CITY OF ALBUQUERQUE

RE: 833 Dolores Dr. NW
Grading and Drainage Plan
Engineer's Stamp Date: 12/13/19
Hydrology File: J11D040

Based upon the information provided in your submittal received 12/13/2019, the Grading and Drainage Plan **is not** approved for Building Permit. The following comments need to be addressed for approval of the above referenced project:

ENGINEER'S SEAL	833 DOLORES DR. GRADING AND DRAINAGE PLAN	DRAWN BY DEM
DAVID SOULE REGISTERED PROFESSIONAL ENGINEER 12/13/19		DATE 12-12-19
DAVID SOULE P.E. #14522	 1608 CENTRAL AVENUE SE SUITE 201 ALBUQUERQUE, NM 87106 (505) 972-0899	833 DOLORES.DWG
		SHEET # C1
		JOB #

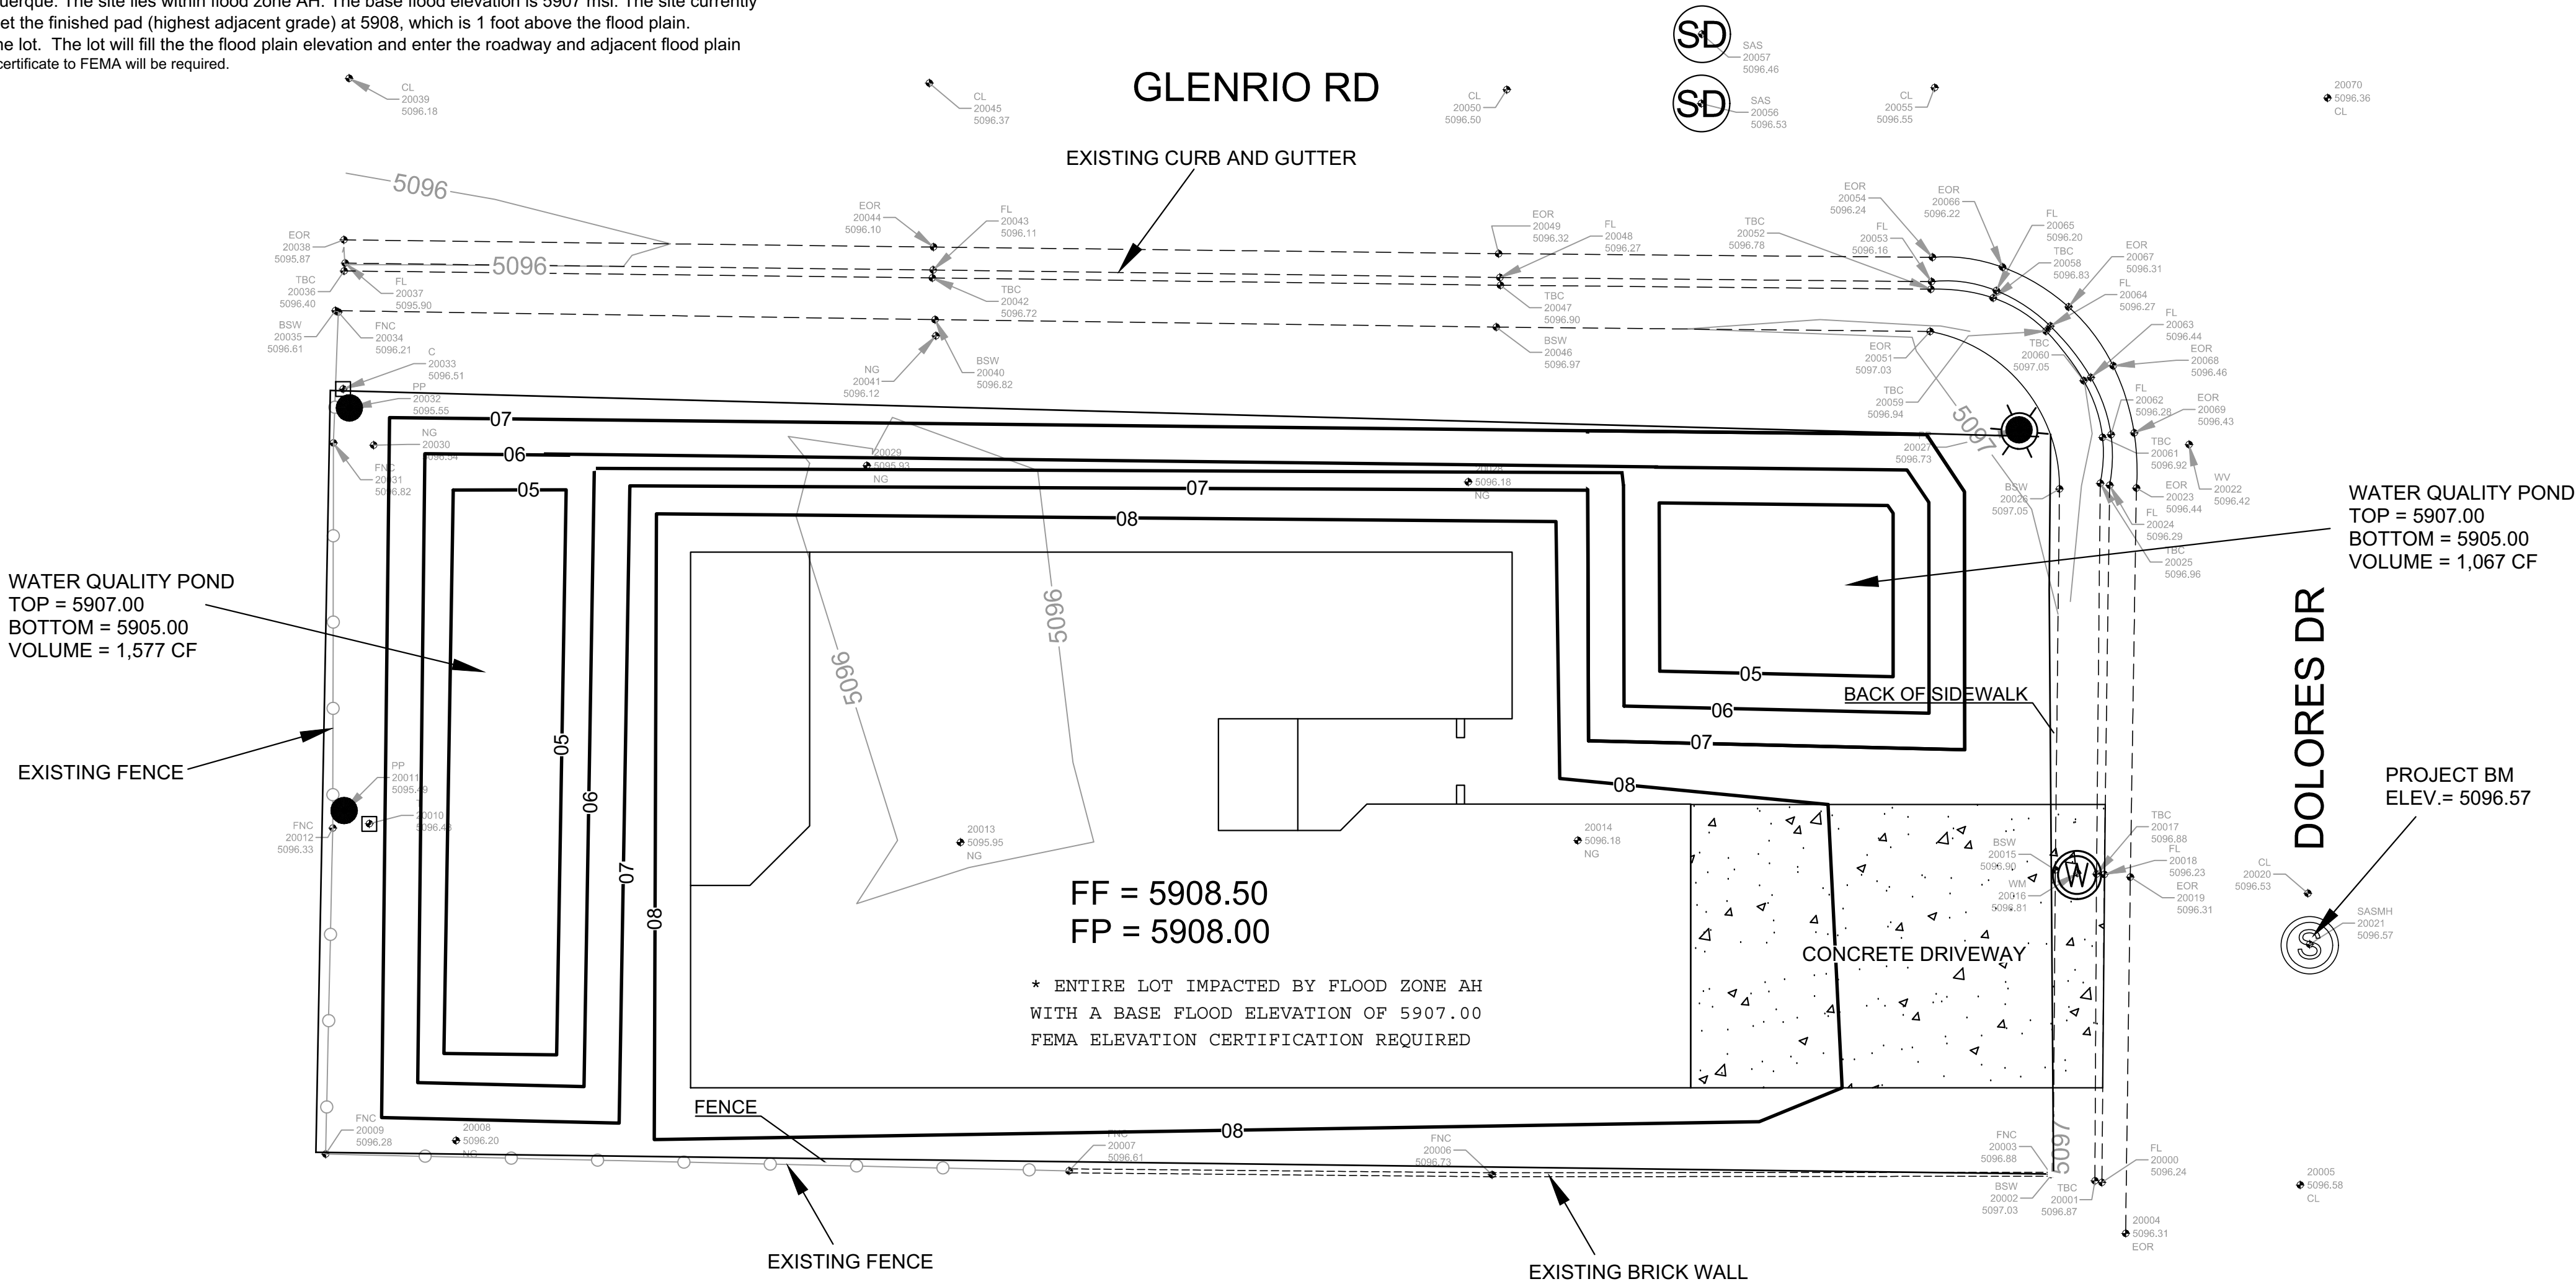
1. As stated on the plans, this site is located in a floodplain (AH – Elev 5907) and must have a floodplain development permit prior to issuing the Building Permit. The permit application must demonstrate zero rise to the base flood elevation, unless a Letter of Map Revision (LOMR) is being prepared. Please contact Rudy Rael, CFM for more information regarding floodplain development permits (rrael@cabq.gov or 924-3977).
2. Since this needs only needs a floodplain development permit, an administration fee of \$40 will be required at the time of resubmittal.
